# UNITED STATES PATENT AND TRADEMARK OFFICE

| APPLICATION NO.   | FILING DATE | FIRST NAMED INVENTOR | ATTORNEY DOCKET NO. | CONFIRMATION NO. |
|---|-------------|----------------------|---------------------|------------------|
| 10/571,215  | 11/15/2006  | Johannes Deichmann   | 502901-341PUS       | 2212             |

# Office Action Summary

## **DETAILED ACTION**

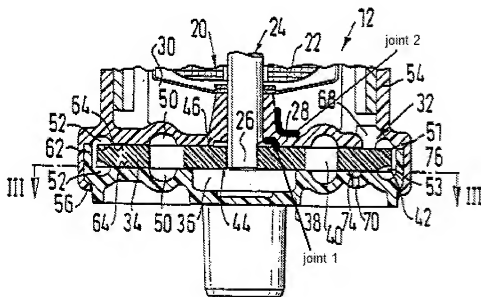
and having a rotor (impeller (34)) of the fuel pump arranged between two housing parts (dividing wall (28) and cover (38)), the rotor being fastened in a rotationally fixed manner to a shaft of the electric motor (see figure 2 with shaft (24)), characterized in that at least one of the housing parts has an expansion joint (The dividing wall (28) has an axial bearing portion that abuts the shaft (24) and a radial portion that encloses the impeller. There are two joints between the axial and radial portions that would allow the assembly to expand and contract as the temperature in the pump unit increases and decreases, see the figure below).

Kemmner et al. teach the fuel feed unit as defined in claim 3 (see the rejection of claim 3 above), wherein the expansion joint on the axial section runs over the entire height of the radial section (the height of joint 1, as shown in the above figure, is approximately the height of the dividing wall (28)).

Kemmner et al. teach the fuel feed unit as defined in claim 3 (see the rejection of claim 3 above), wherein the expansion joint is arranged in the corner region at which the two sections adjoin one another (both joint 1 and joint 2, as shown in the above figure, are located at a corner formed between the axial section and the radial section of the wall).

Kemmner et al. teach the fuel feed unit as defined in claim 3 (see the rejection of claim 3 above), wherein the expansion joint is arranged on the side of the housing part facing toward the electric motor which faces away from the rotor (joint 2, as defined in the above figure, is arranged on the side of the wall that faces the pump motor).

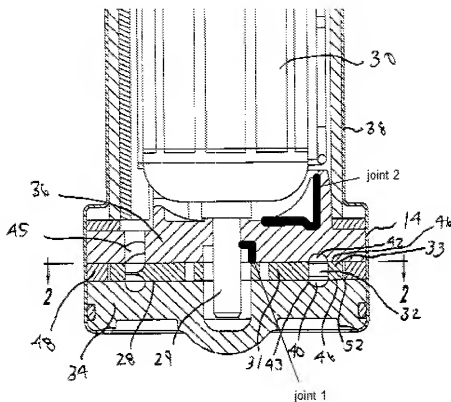
Iwai et al. teach a fuel feed unit for a motor vehicle (see column 1 lines 5-10) having a fuel pump (see figure 1) which is driven by an electric motor (electric motor (10)), and having a rotor (impeller (3)) of the fuel pump arranged between two housing parts (pump base (1) and pump cover (2)), the rotor being fastened in a rotationally fixed manner to a shaft (shaft (4)) of the electric motor, characterized in that at least one of the housing parts has an expansion joint (The pump base (1) has an axial bearing portion that abuts the shaft (4) and a radial portion that encloses the impeller. There are two joints between the axial and radial portions that would allow the assembly to expand and contract as the temperature in the pump unit increases and decreases, see the figure below).

Iwai et al. teach the fuel feed unit as defined in claim 3 (see the rejection of claim 3 above), wherein the expansion joint is arranged on the axial section near the rotor and is embodied as a spacing of the housing part from the shaft (Joint 1, as defined in the above figure, is formed as a cut out in the axial section of the base (1), in such a way that the base is spaced from the shaft).

Iwai et al. teach the fuel feed unit as defined in claim 3 (see the rejection of claim 3 above), wherein the expansion joint runs over approximately half of the axial section (Joint 1, as defined in the above figure, is approximately half the height of the base (1)).

Iwai et al. teach the fuel feed unit as defined in claim 3 (see the rejection of claim 9 above), wherein the expansion joint is embodied as a groove which runs all the way around the axial section (Joint 1, as defined in the above figure, is formed as a groove which surrounds the shaft and is located in the axial section of the base (1)).
